# UNITED STATES PATENT AND TRADEMARK OFFICE

10/788,785

<b>Office Action Summary</b>	<b>Application No.</b> 10/788,785	<b>Applicant(s)</b> JOHNSON ET AL.	
	<b>Examiner</b> Adriana Figueroa	<b>Art Unit</b> 3637

**DETAILED ACTION**

FIG. 2

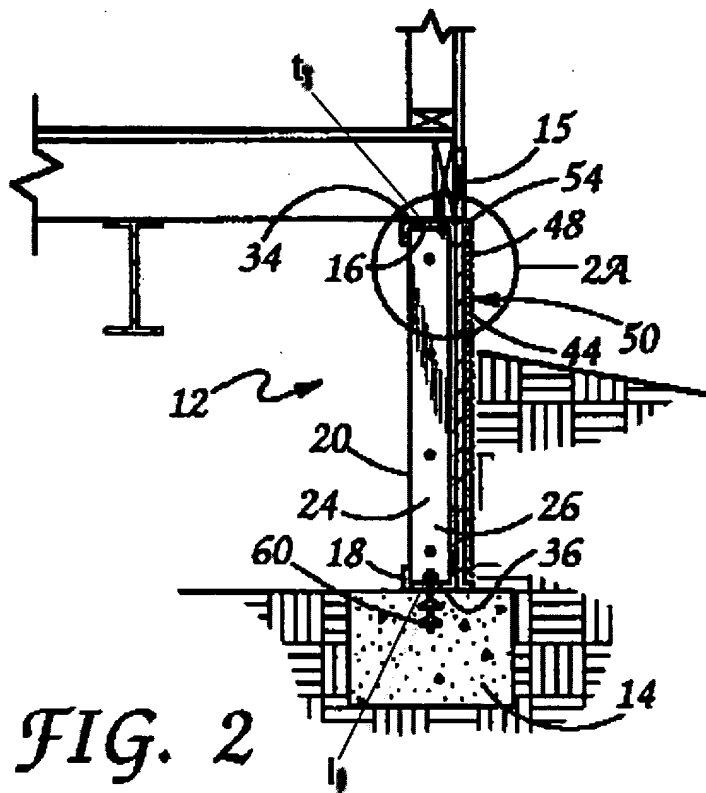
Regarding claim 1, Wolfrum discloses a panel having a member (48) comprising an outwardly-directed surface (o) to which the ornamental façade (50) is affixed, and an inwardly-directed surface (i) to which a support framework (F) is integrally coupled, (annotated Figures 2A, 4); said support framework (F) comprising a first section (16, 18, 20R, 20L) located generally along the periphery of said inwardly-directed surface (i) and at least one interconnect section (20) extending between said first section (annotated Figures 2A, 4); and a plurality of apertures (58) through a lower length (18) of said first section, each said aperture sized for accepting a fastener (60) permitting the securing of the panel to the foundation (14), (Figures 2, 3), (Column 4, Lines 16-19).

Regarding claim 7, Wolfrum modified by Barylski discloses as discussed in claim 1.; Wolfrum teaches a plurality of the panels wherein: the foundation (14) comprises a compressive-support material within a ground, said compressive-support material being concrete which is made of cement, (Figure 2), (Column 2, Lines 55-56).

Wolfrum discloses for each of the panels, each said lower-end ledge (l) comprises an aperture for accepting a fastener (60) permitting the securing of the panel to the foundation (14), (annotated Figure 2).

FIG. 4

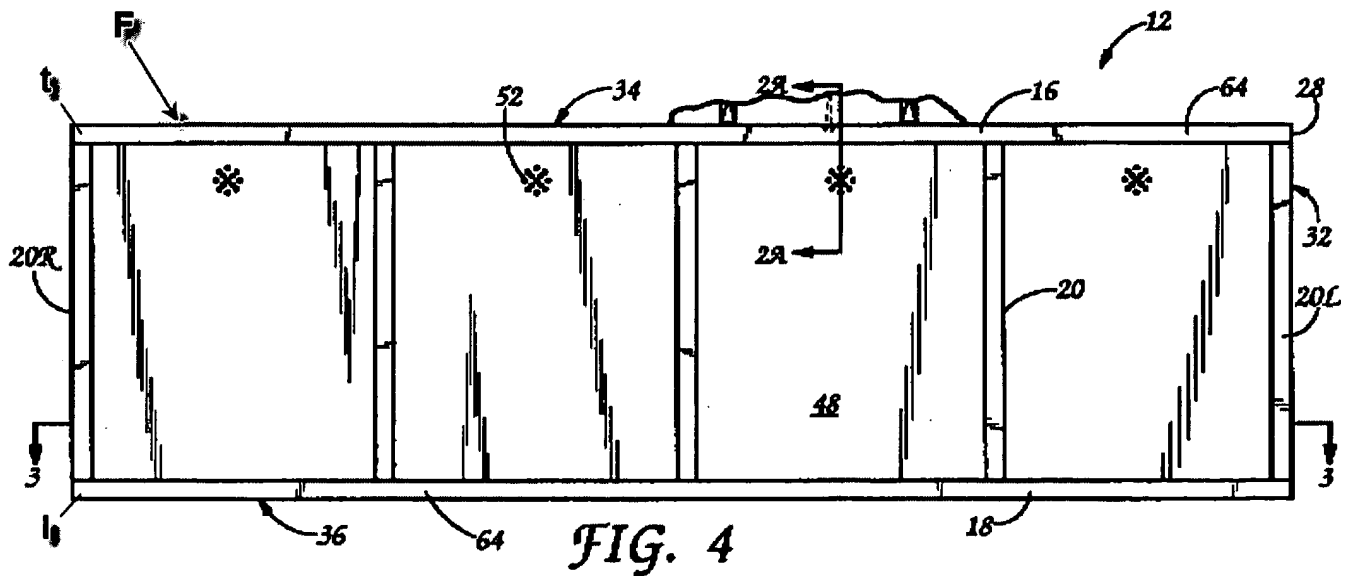
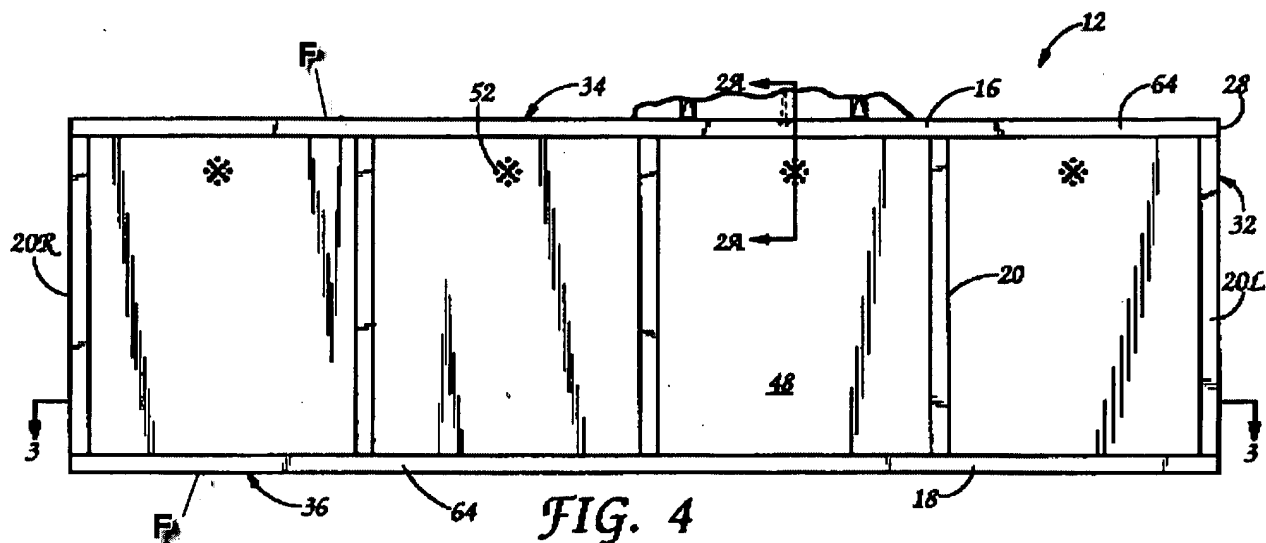
comprises right-side (20R), left-side (20L), and upper (16) sections, each said section having a plurality of apertures (58, 62) therethrough (Figures 2A, 3A, 4); and said support framework (F) and said plastic member (48) are integrally fabricated, (Figure 4).

Wolfrum modified by Barylski, Hasecke and Hazan disclose said support framework (F) and said plastic member (48) are integrally fabricated, (annotated Figure 4).

Wolfrum modified by Barylski, Hasecke and Hazan discloses said support framework (F) and said plastic member (48) are integrally fabricated, (annotated Figure 4).

Wolfrum discloses said support framework (F) and said member (48) are integrally fabricated, (Figure 4).

FIG 3

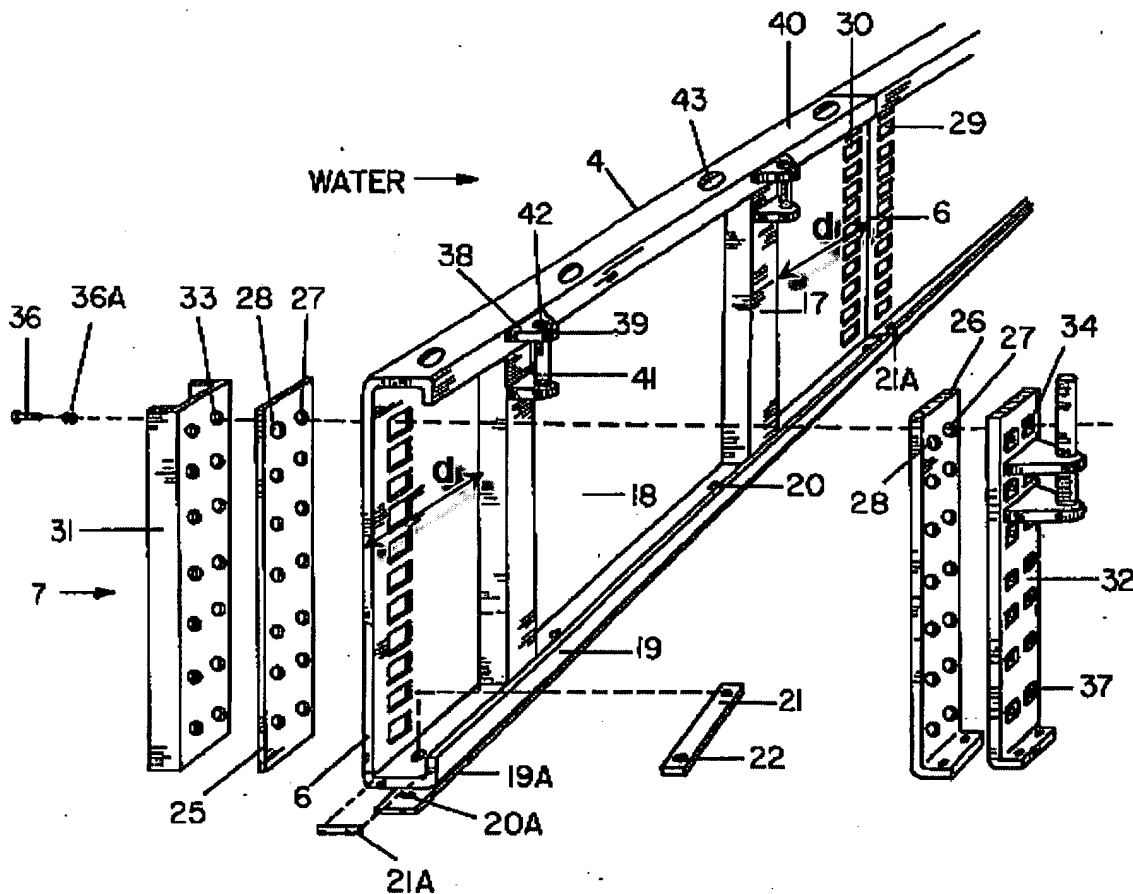
to said inwardly-directed surface (18) a distance (d) from a respective right and left periphery (6) of said inwardly-directed surface, (annotated Figure 3). Therefore, it would have been obvious to a person having ordinary skill in the arts at the time of the applicant's invention to modify the panel of Wolfrum and Barylski to include right-side and left-side sections coupled to said inwardly-directed surface as taught by Clark in order to provide a stronger panel.
